This guide briefly illustrates how to rework the LI-JTX1-MIPI-ADPT REV1.2 board for Xavier platform.

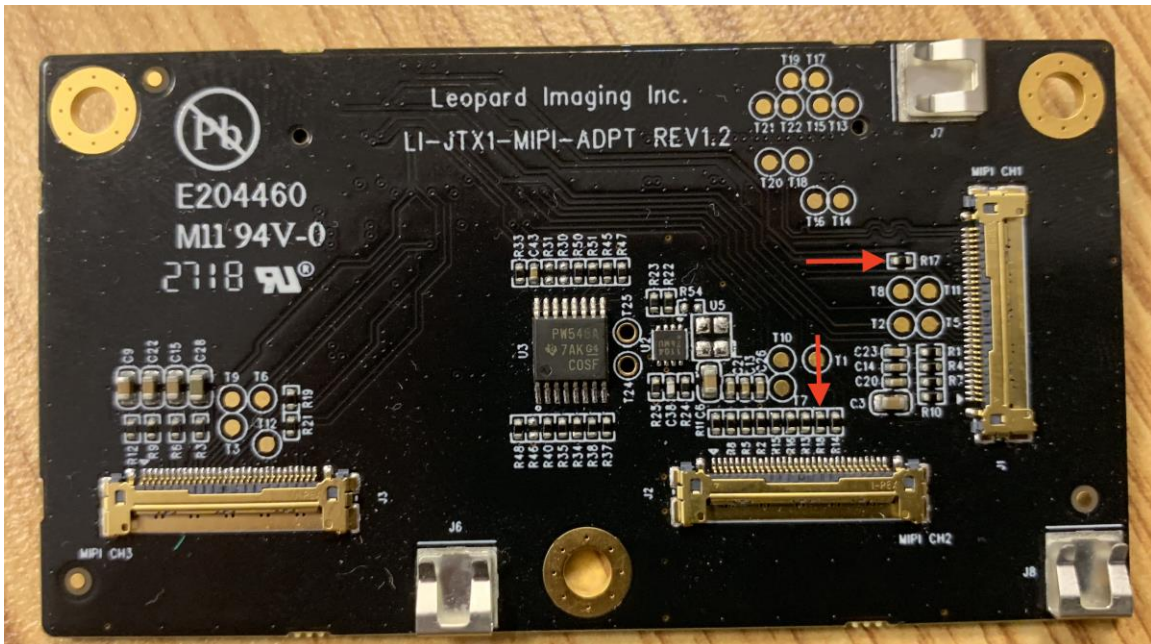
Remove R17 and R18 from the LI-JTX1-MIPI-ADPT board.

Note: Do not remove R19.
